MEMO

To: Kristopher Byrd, Well Construction and Compliance Section Manager
From: Joel Jeffery, Well Construction Program Coordinator
Subject: Review of Water Right Application G-18700
Date: July 25, 2018

Groundwater Application Review Summary Form

Application # G- 18700

Water-Level Trends in Nearby Wells

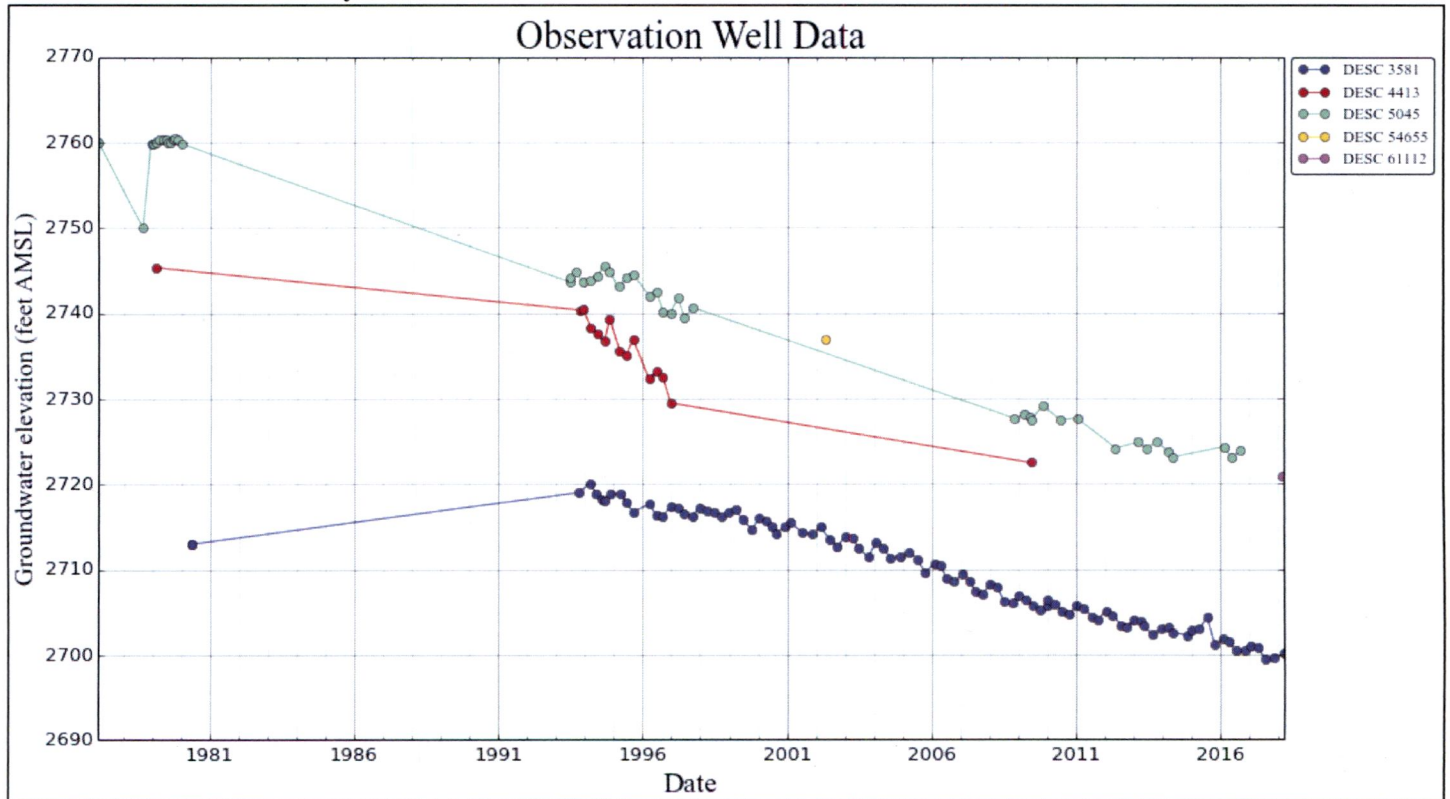
B3. **Groundwater availability remarks:** The nearest, relevant, State Observation Wells are DESC 4413 (located approximately 1.8 miles to the east), DESC 3581 (located approximately 5.5 miles to the northeast) and DESC 5045 (located approximately 6.5 miles to the southeast). DESC 4413 was monitored periodically during the 1990's, while DESC 3581 and DESC 5045 have been monitored periodically since at least the 1990's through the mid 2010's. DESC 3581 and DESC 5045 both show a relatively steady decline of approximately 1 foot per year since 1994 to present. Of the nearby wells (Sections 8-10, 15-17, and 20-22), DESC 54655 (drilled in 2002) has a similar well depth as the applicant's well (DESC 61112); based on the static water level listed on the well logs for these two wells it appears that the declining water levels are also occurring in this area. The water level declines seen throughout the region are likely mainly due to decreased recharge but also due to increased pumping.
